**Staff Report: Preliminary Plan 120080070, Ashton Meeting Place
 Site Plan 820080040, Ashton Meeting Place**

APPLICATION DESCRIPTION:

Creation of 1 lot for 74,000 square feet of commercial space, and seven one-family detached residential units on 9.26 acres in the C-1, R-60, R-C and Sandy Spring/Ashton Rural Village Overlay Zones; located at the southeast quadrant of Ashton Road (MD 108) and New Hampshire Avenue (MD 650); Sandy Spring/Ashton Master Plan

RECOMMENDATION: Approval of the preliminary and site plans with conditions

Illustrative Plan

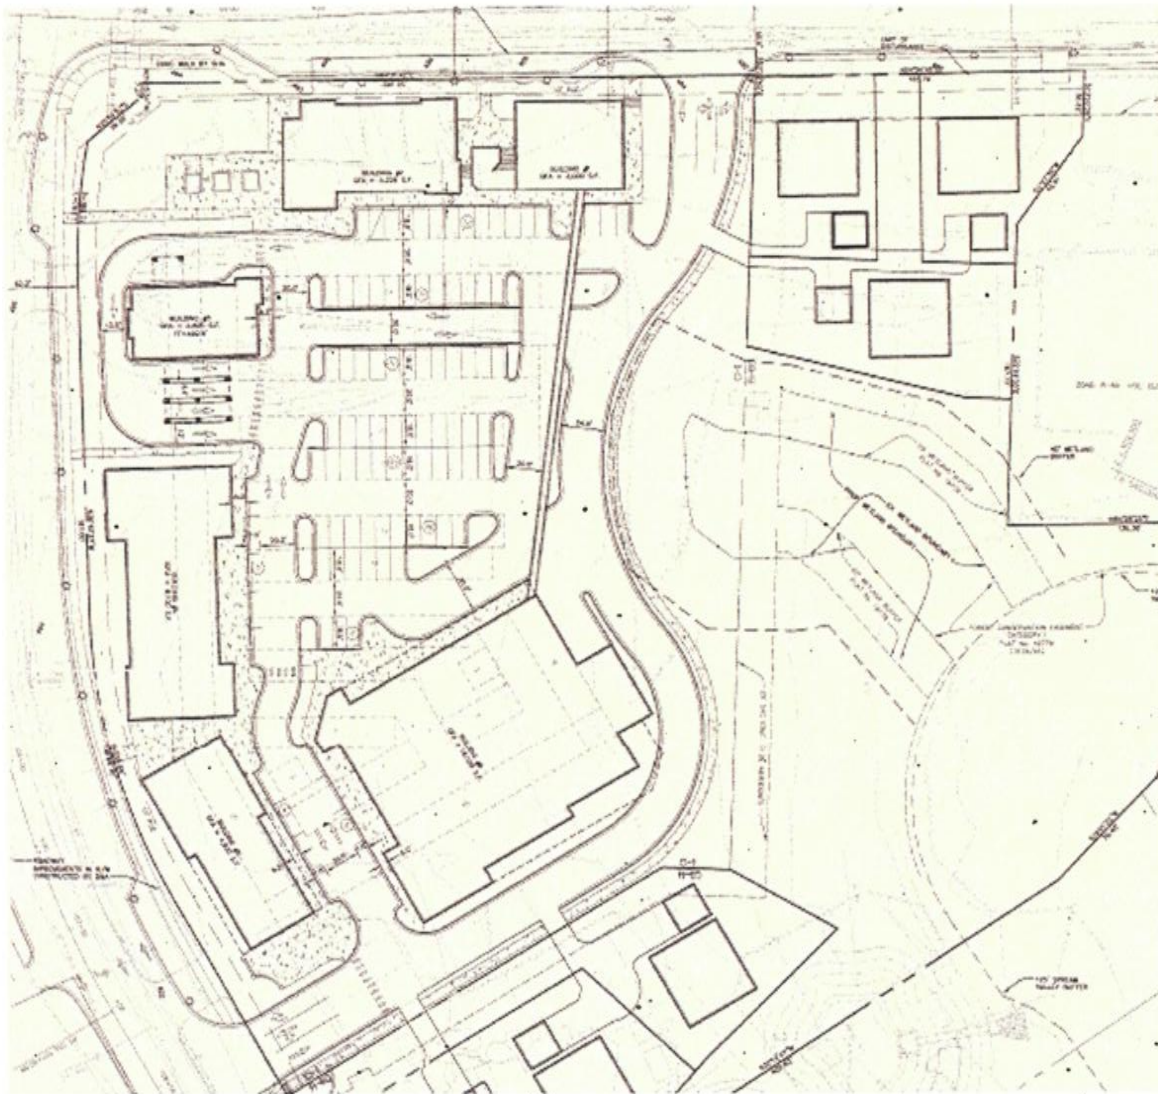
The Applicant has since worked with the community and Staff to create a plan that addresses the previous findings. After numerous meetings and design charettes, the current site plan proposal was submitted.
